NOTICE UNDER SCHEDULE VI CHAPTER XI, RULE 2 (I) OF
THE CITY OF KARACHI MUNICIPAL ACT 1933.

Pursuant to the provision of Schedule VI, Chapter XI, Rule (1) of the City of Karachi Municipal Act 1933, I hereby give you notice that I intend with the meaning of that rule to erect a building on plot No. 127 Survey Sheet S.R. 5 Situated in Narain street Serai Quarter as per Ground plan, Elevation and Section sent herewith in quadruplicate,

No. B. S. P. 673/34

Case No. P/C 673/34.

SECTION ON A-B

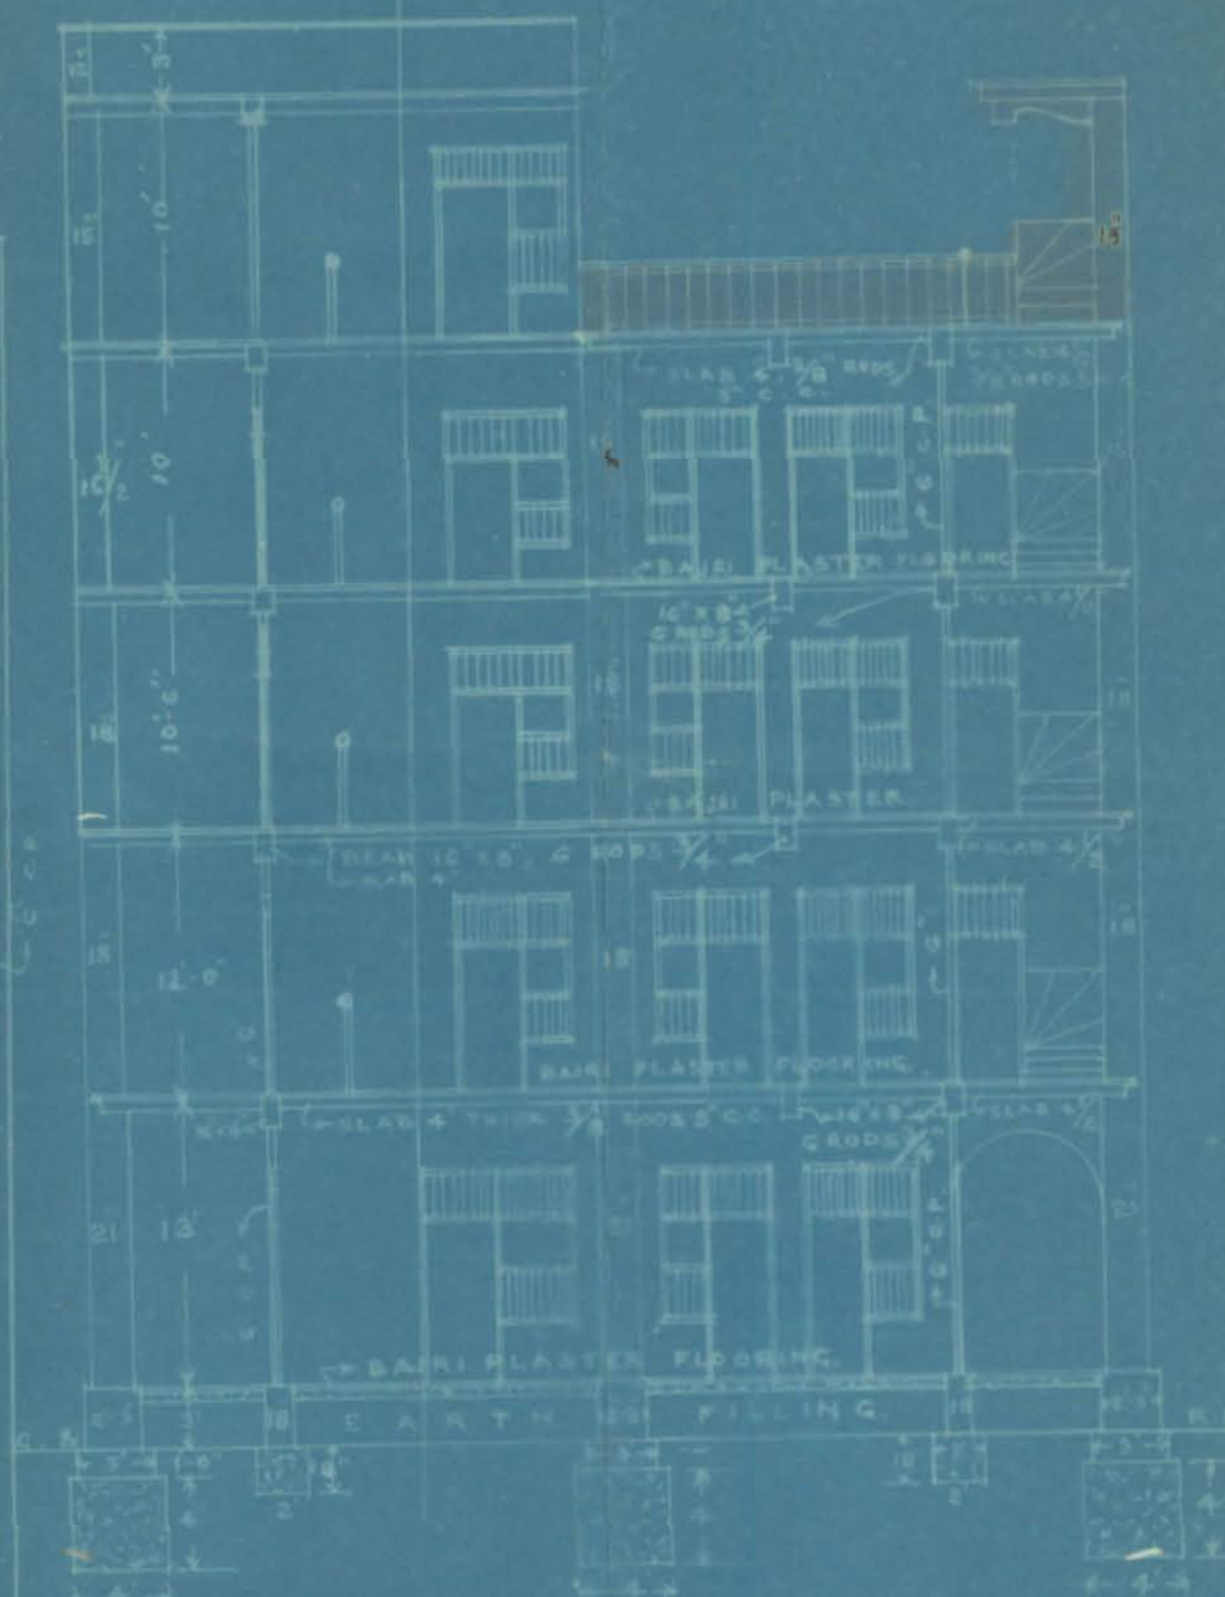
1. Plot no. as per subdivision must be given on the plan.
2. Measurements of dickies must be given.

(2) Plot Numbers are not correctly
shown as per sanctioned sub-division

Plot No. as per
sanctioned sub division
map shown
correctly
25/1

(1) Dicky measurements
are shown by the architect

—AMENDED PLAN—

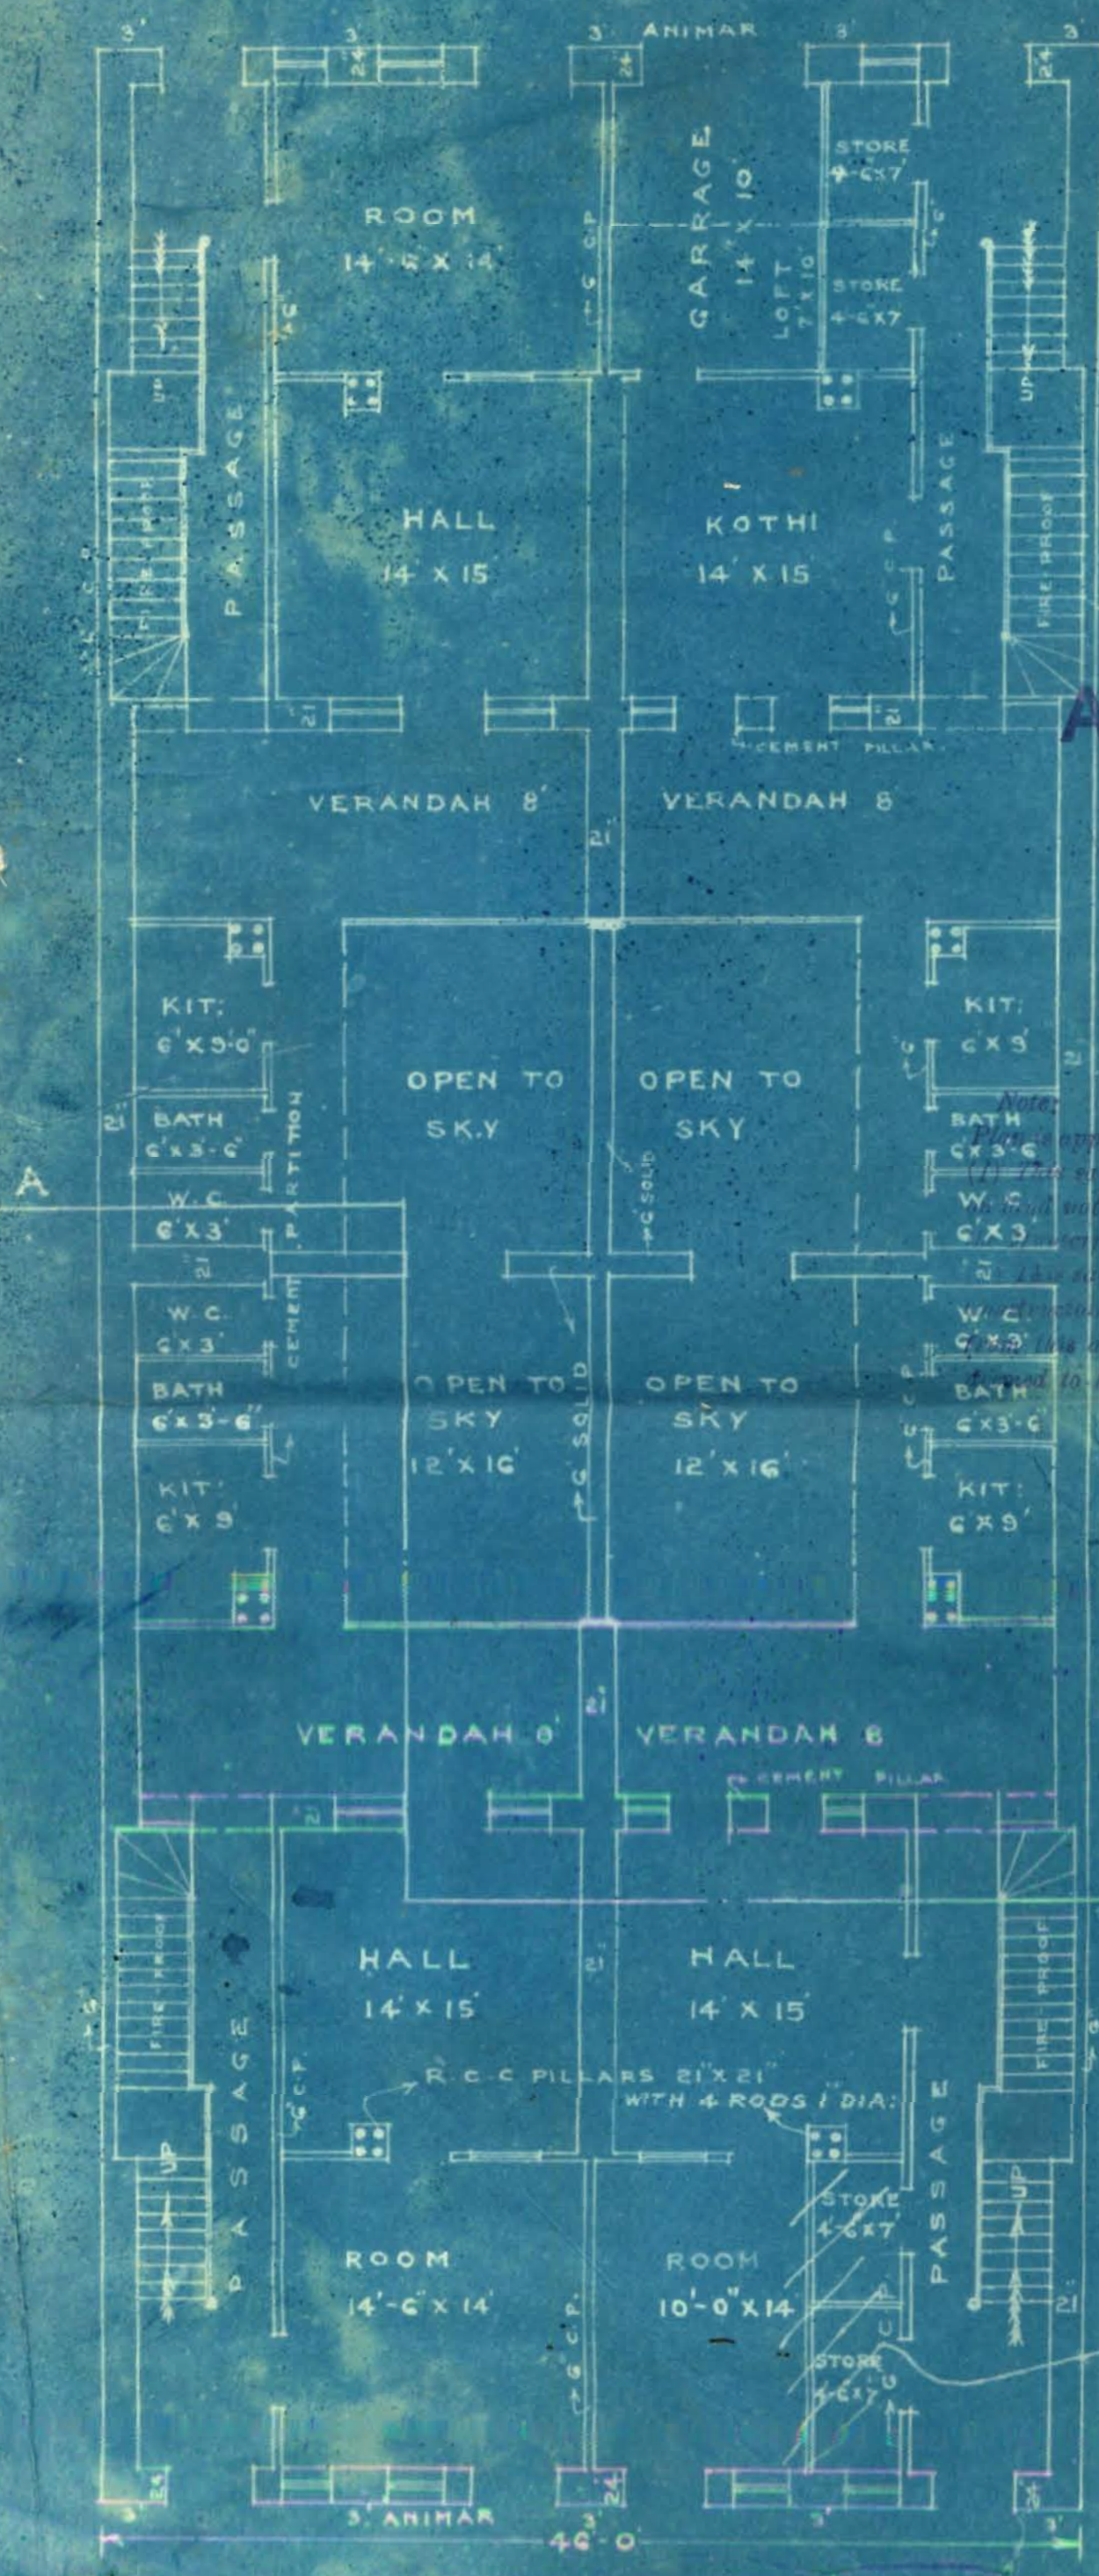
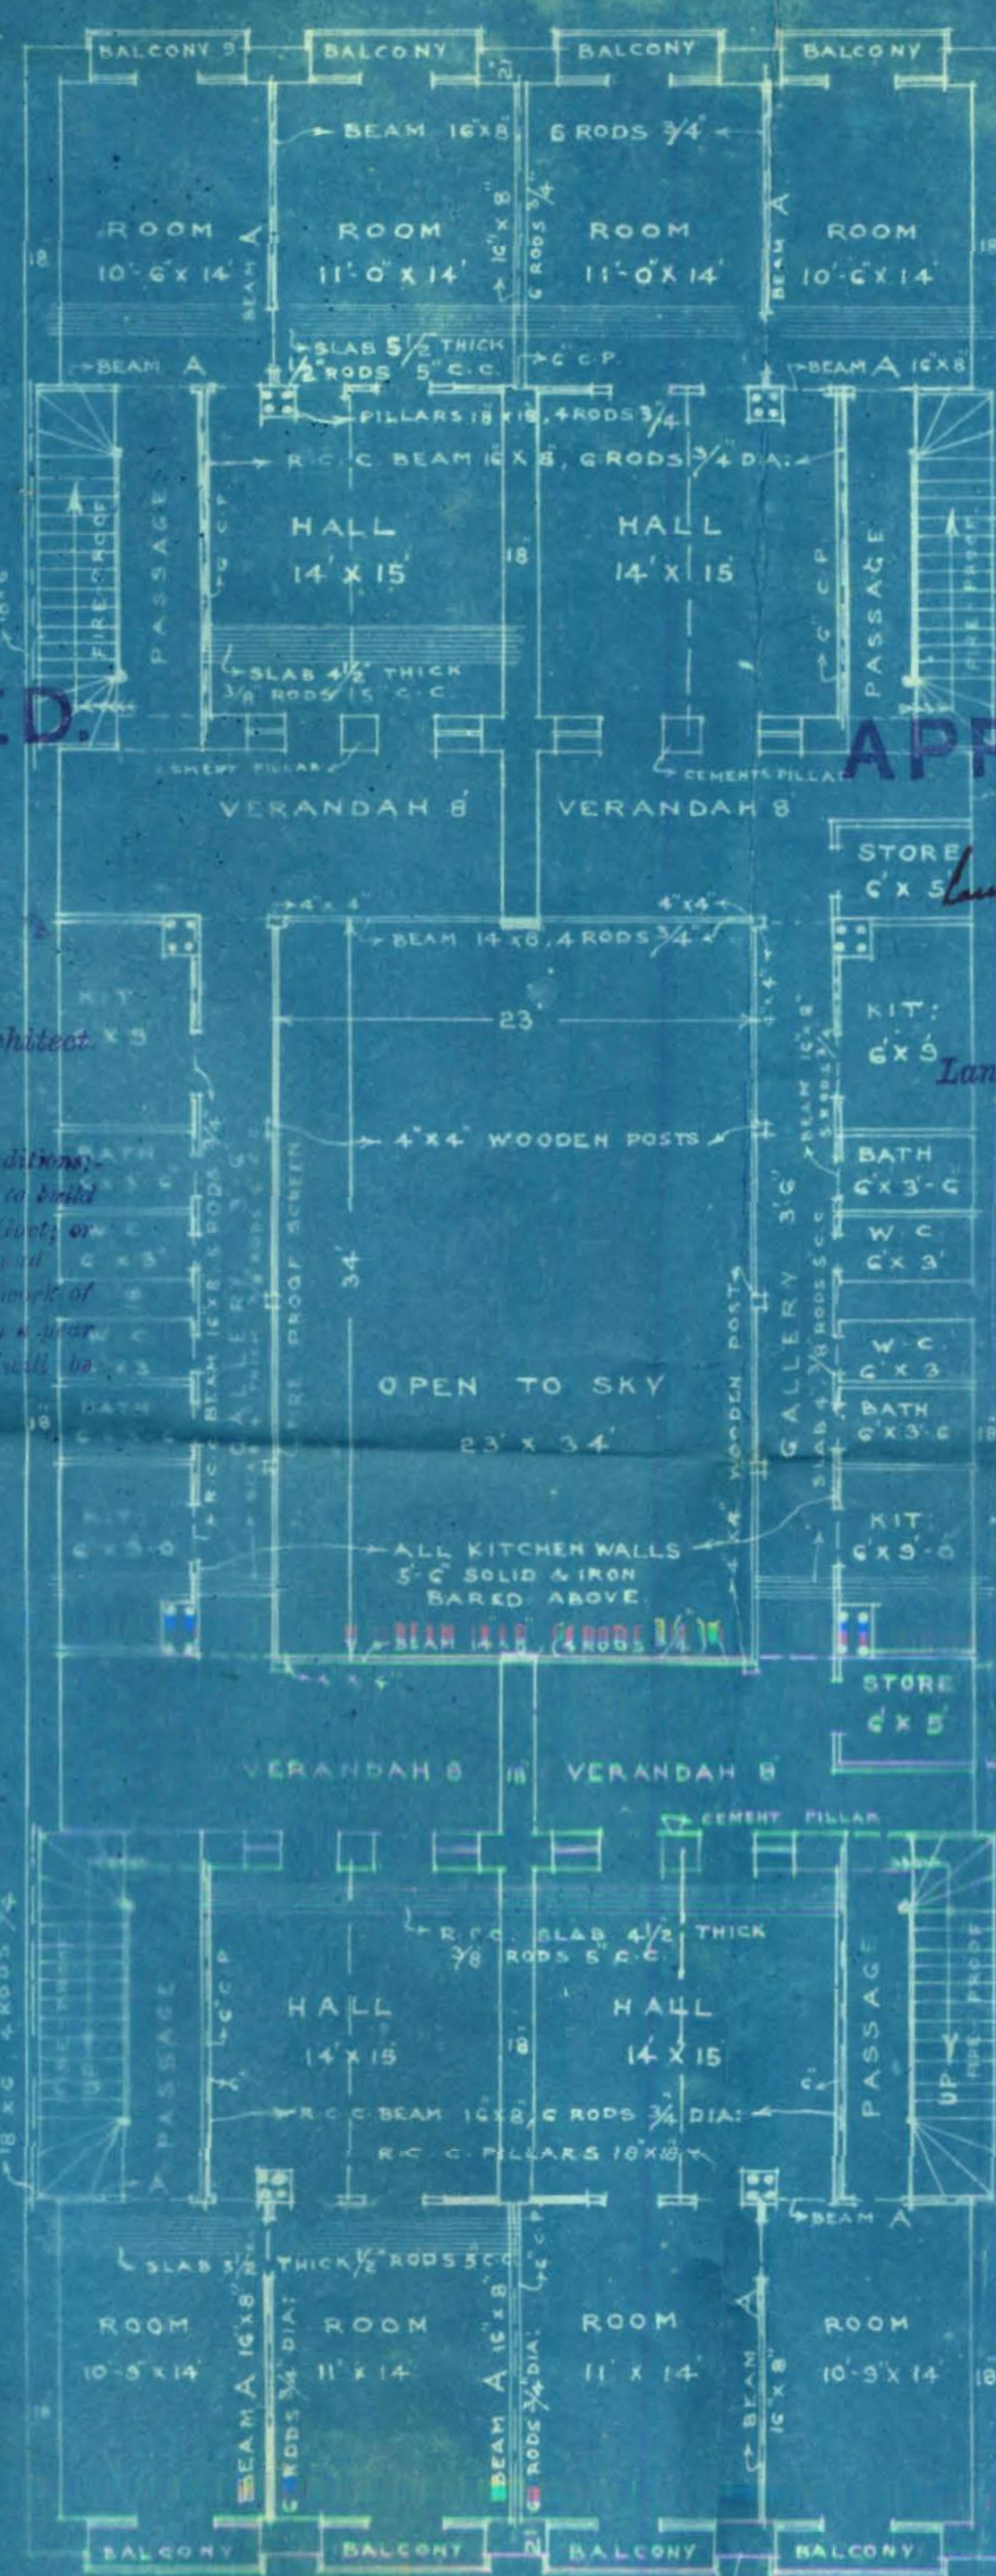
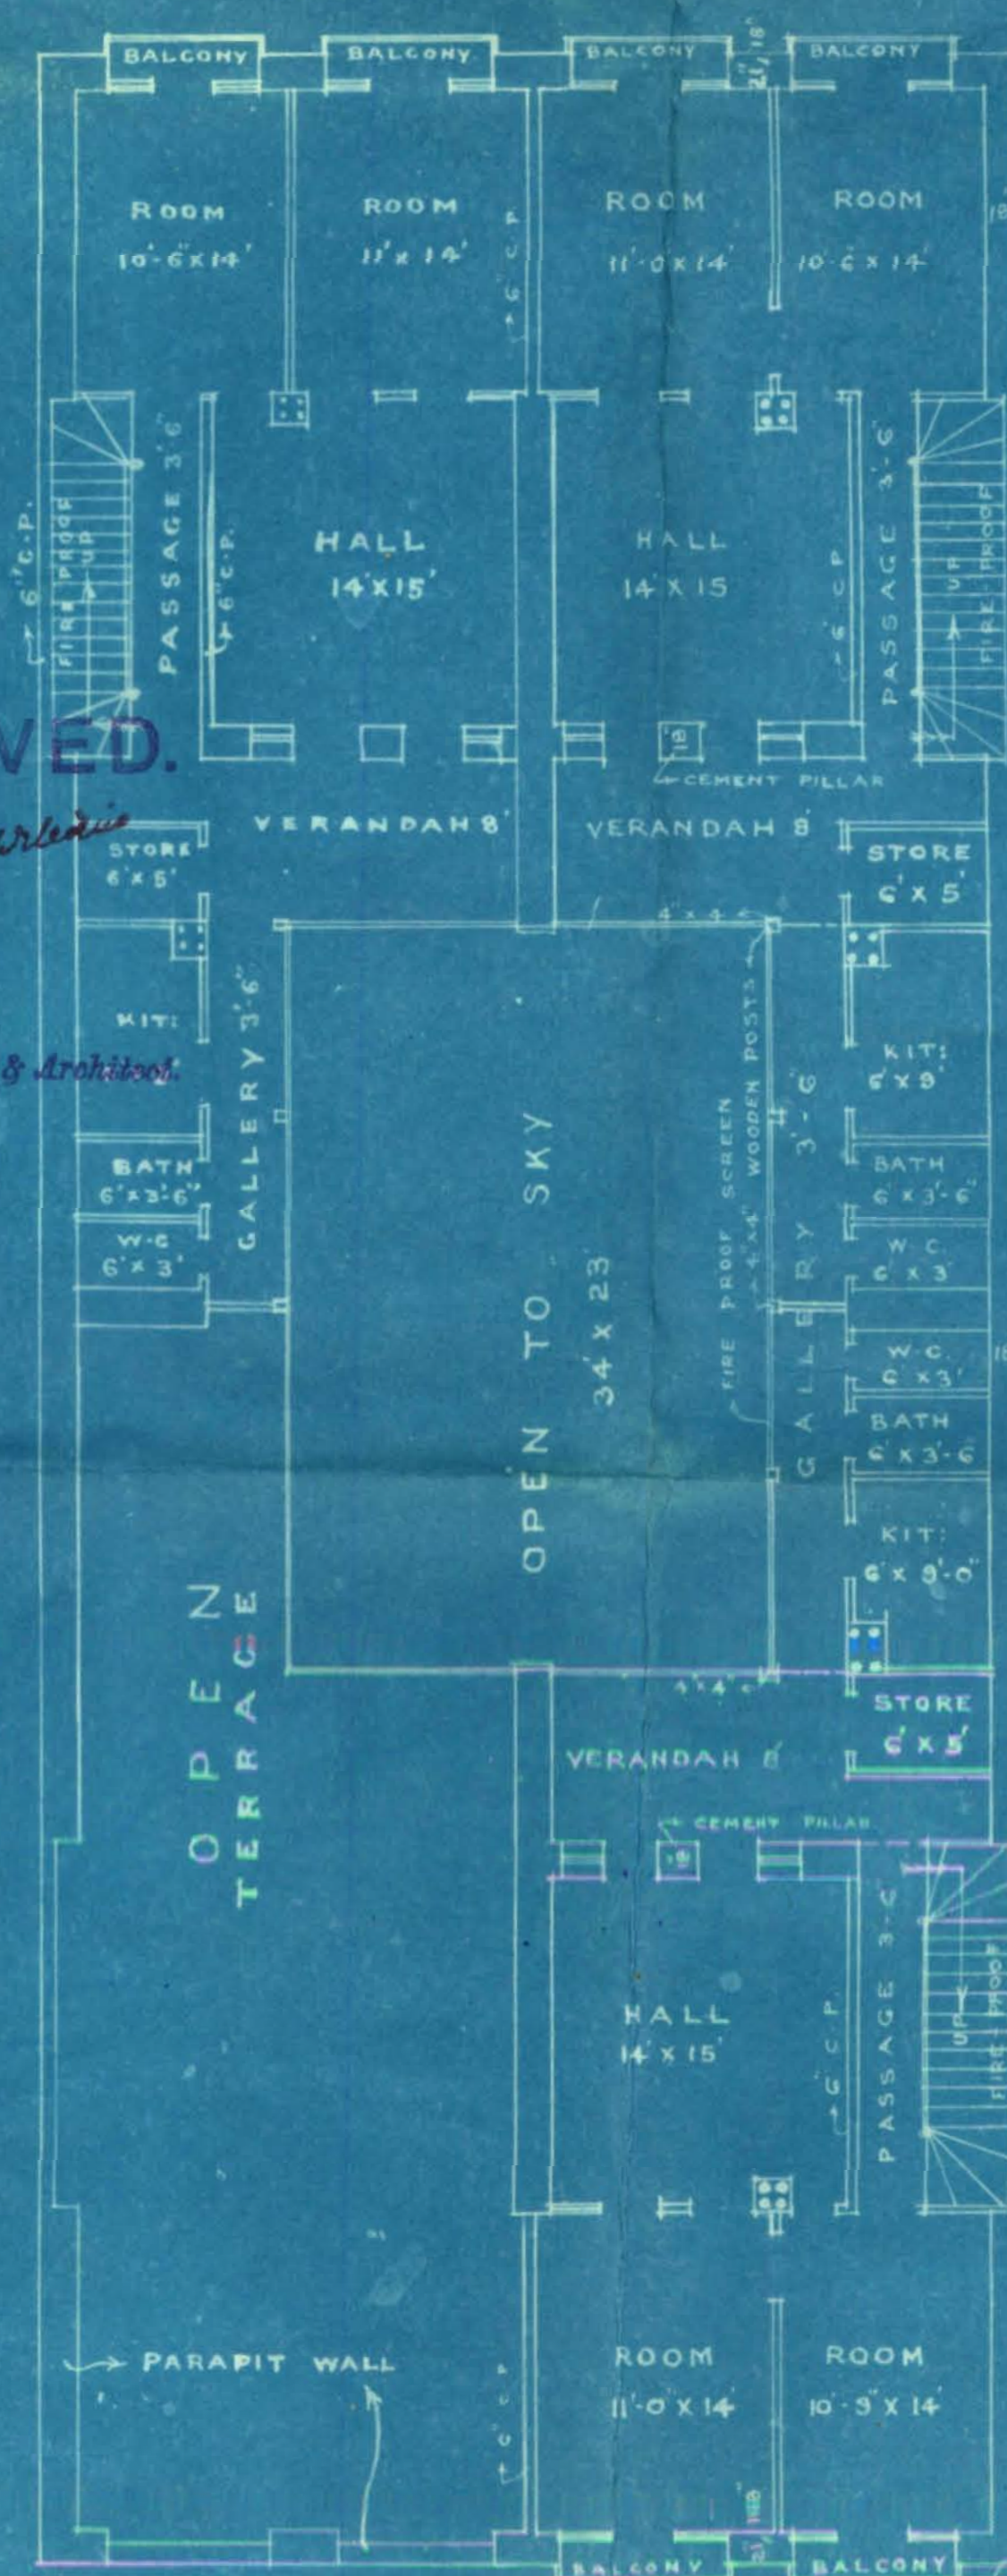
With reference to your applications dated 30 . 1 . 193 5
for the proposed additions & alterations on the above plot, you
are required to submit one more copy of the
correct plan on CLOTH .

Dated 11th Feb: 1935. We have the
 honour to submit herewith one
 more Copy on Cloth for Building
 on plot no. 129/1 & 129/2 sheet
 No. S.R. 7. Sarai Quarter, as
 desired. Now the plans may
 kindly be approved soon.
